Last saved	11/10/2016 16:14
Path	FDfd-12336-59-121016-26 West End Lane-F2.doc
Author	F Drammeh, MEng (Hons)
Project Partner	E M Brown, BSc MSc CGeol FGS
Project Number	12336-59
Project Name	26 West End Lane
Planning Reference	2016/2083/P

## 26 West End Lane, NW6 4PA BIA – Audit

Response to Campbell Reith Hill's

# Further Response to Audit of 26 Westend Lane London NW6 4PA

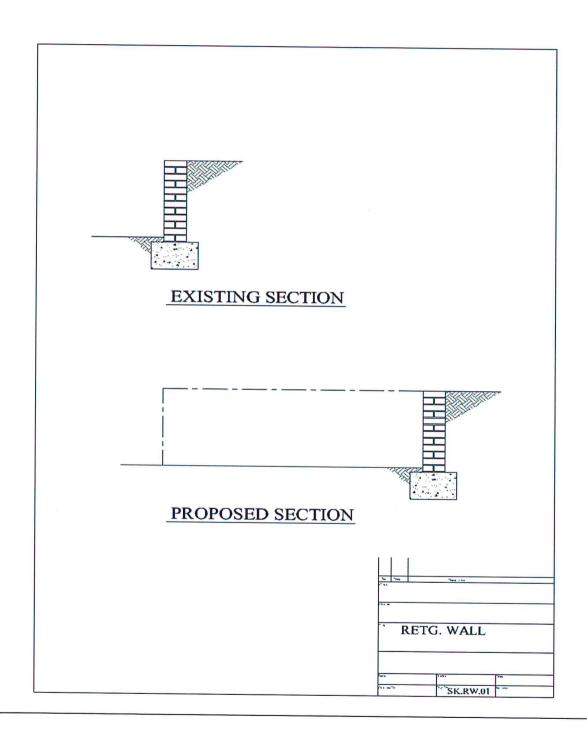
- 4.3. The screening process was not fully undertaken. The land stability screening questions were not answered. In response to the initial audit, rather than undertaking the screening, TZG again referred to Cl. 234 of the Arup GSD which was referenced in the BIA and stated 'the 0.90m deep excavations at this development will not have any effect on any macro topographical features. On a micro level, the proposed excavation will not extend beneath the footings of any adjacent property'. These have now been answered although no justification is provided for the 'No' responses.

4.3 Reference again, is made to CL. 234. There are no matters of concern. Figure 4 "slope stability screening flowchart" is for a basement. It is not applicable to a garden wall.

The moved retaining wall will continue to sit at the same level it currently sits.

- 5.2 For the avoidance of doubt showing a section through the new retaining is provided.
- 5.4 TZG's response is covered in the items above.
